REMARKS

Amendments to the Drawings:

The drawing sheets attached in connection with the above-identified application containing Figures 2-4 are being presented as a new formal drawing sheets to be substituted for the previously submitted drawing sheets. The drawing Figures 2-4 have been amended. Appended to this amendment is an annotated copy of the previous drawing sheet which has been marked to show changes presented in the replacement sheet of the drawing.

Fig. 2

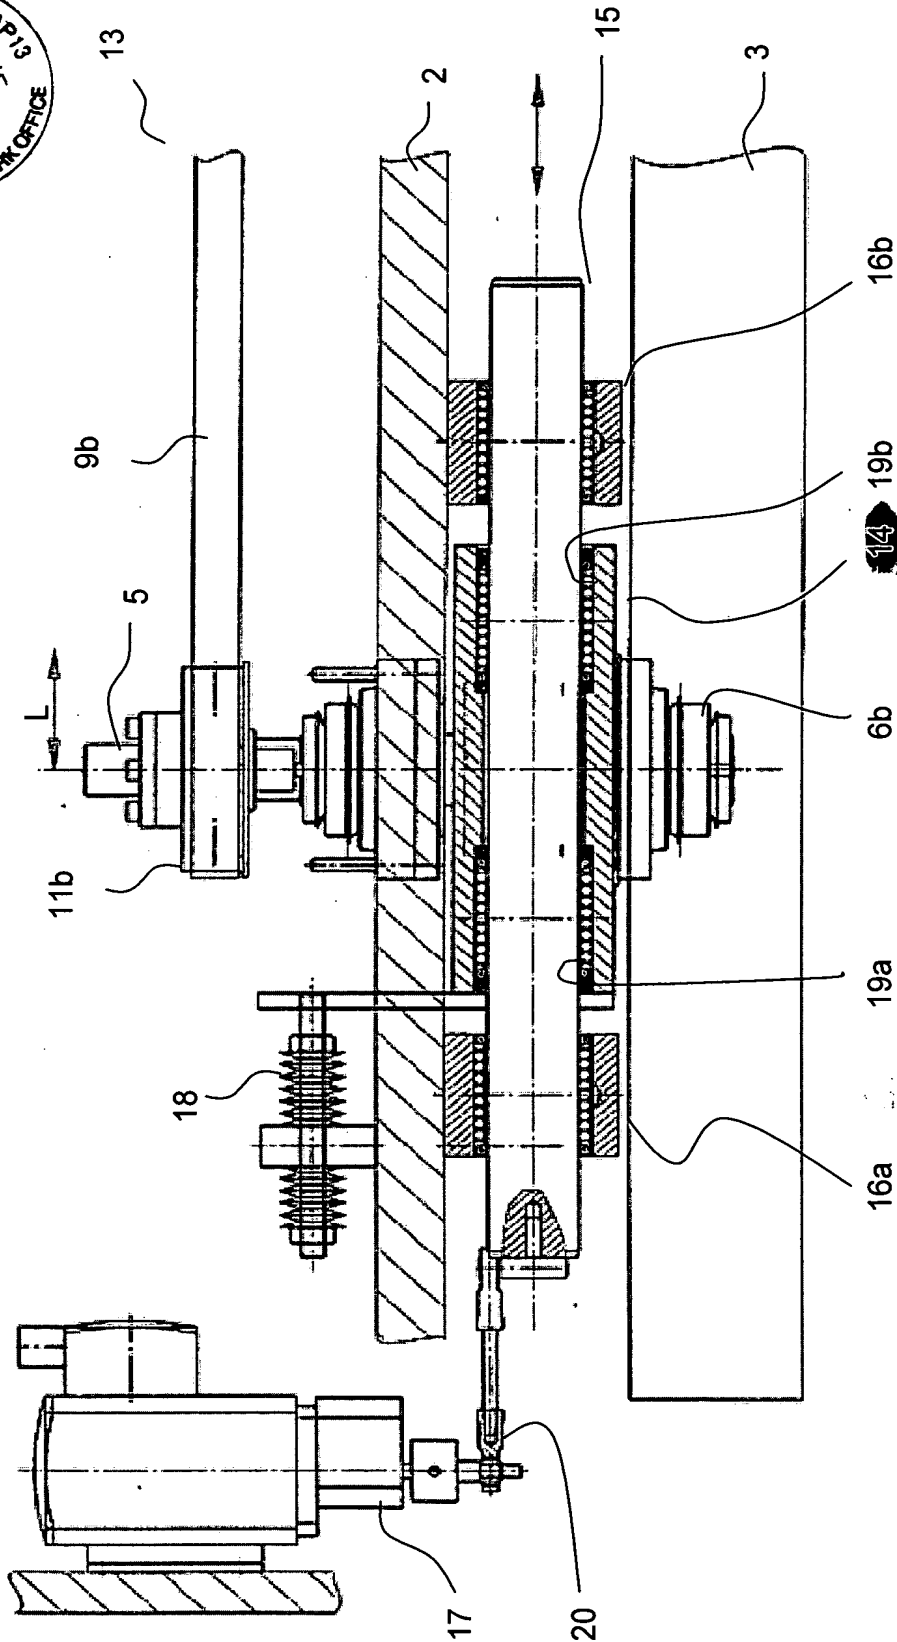
The drawings were objected to as failing to comply with 37 CFR 1.84(p)(4). Specifically, the Office Action states on page 2, "reference characters '7' and '14' have both been used to designate support." The specification and Fig. 2 have been amended to clarify that only reference numeral 14 refers to the support, thus overcoming this objection to the drawings.

The specific changes which have been made to Figure 2 are to change the reference numeral 7 to 14 for labeling the support. Figure 3 has been amended to include reference numerals 5, 14, 16a, 16b and 18 to label features mentioned in the specification. Figure 4 has been amended to extend the lead line from reference numeral 28 to the inner ring of bearing 24.

Fig. 3

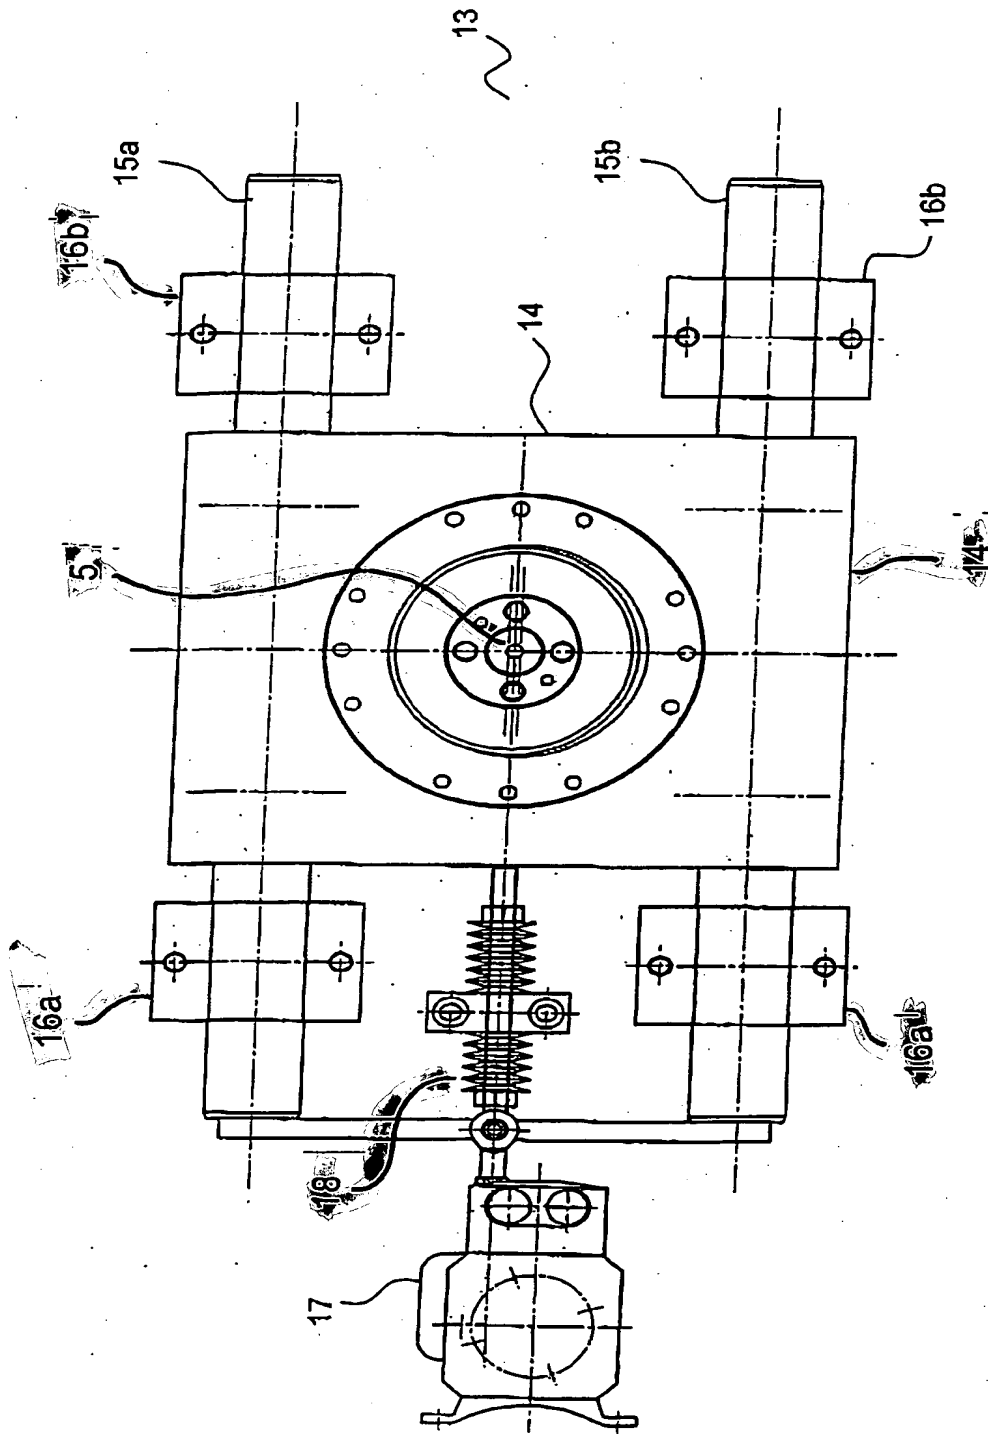
The drawings were also objected to for not labeling elements in Fig. 3, and in Fig. 4 because reference character 28 is not pointing to the inner ring of bearing 24. Fig. 3 has been amended to label elements not labeled, and Fig. 4 has been amended such that reference numeral 28 points to the inner ring of bearing 24, thus overcoming the objections to the drawings.

Fig. 4

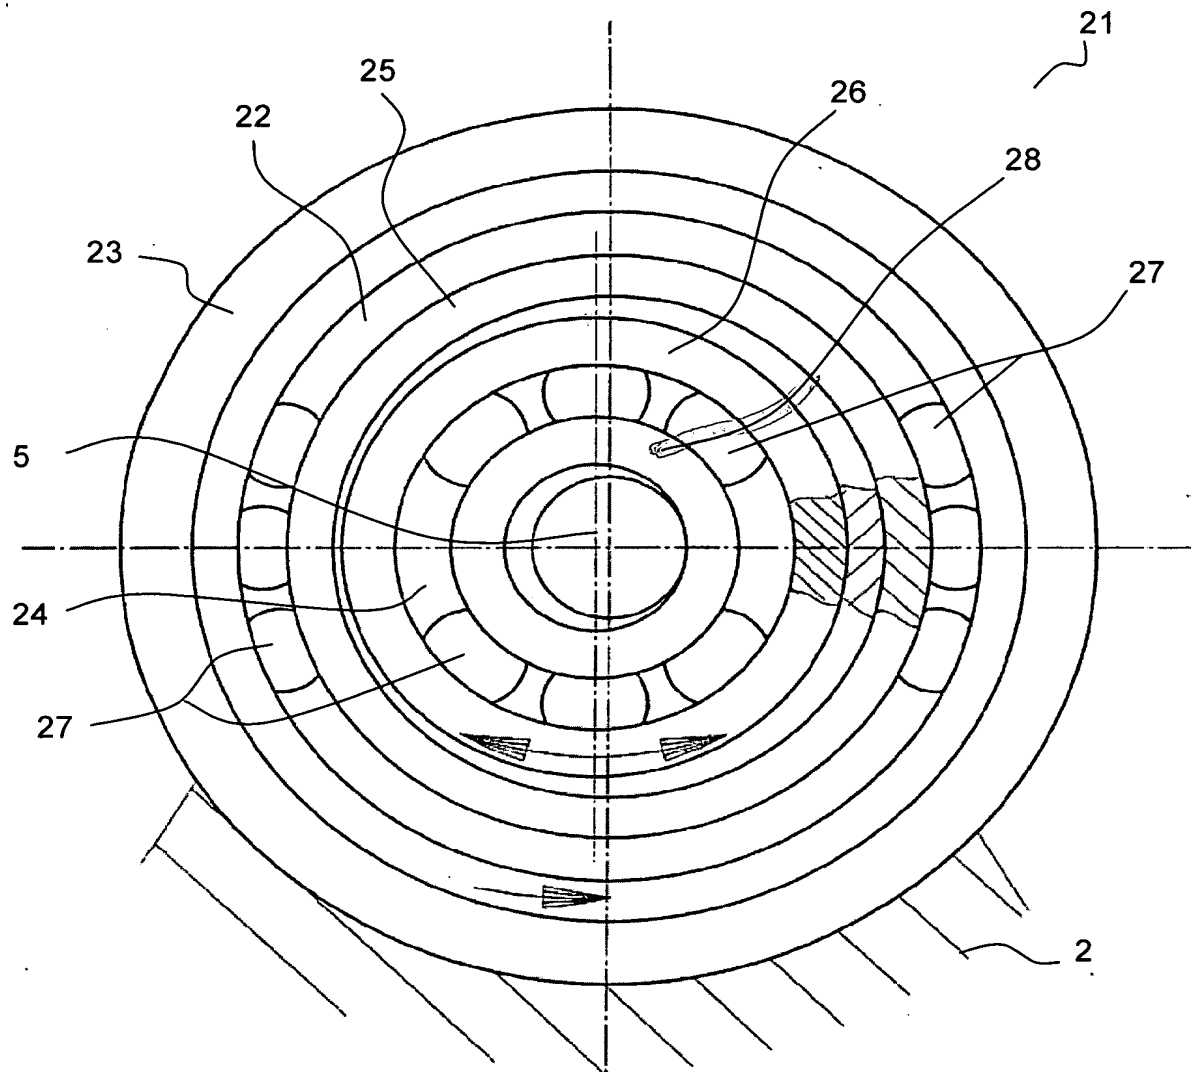
With respect to the second embodiment of Fig. 4, the specification in paragraph [0051] provides: "The outer ring 26 of the first rolling-contact bearing 24 and the inner ring 25 of the second rolling-contact bearing 22 are connected to one another, and together form a connecting bearing shell...". Thus, as clearly disclosed in the specification, the outer ring 26 and the inner ring 25 are connected to each other. Furthermore, Fig. 4 does not illustrate any gaps between between the outer ring 26 and the inner ring 25. In Fig. 4, which is a technical drawing, the rings 26 and 25 as well as the region between the rings are illustrated with a partial cut away that is hatched. Thus, the region between the rings 25 and 26 comprises a material, just as the rings themselves do. Fig. 4, therefore, illustrates no gaps between the rings 25 and 26. While the hatching of the rings and in the region between is shown in a

cutaway view, and is not illustrated over the entire ring or region between, such cutaway views are common practice in technical drawings, and one skilled in the art would recognize that the entire rings 25 and 26, as well as the region between, are composed of material.
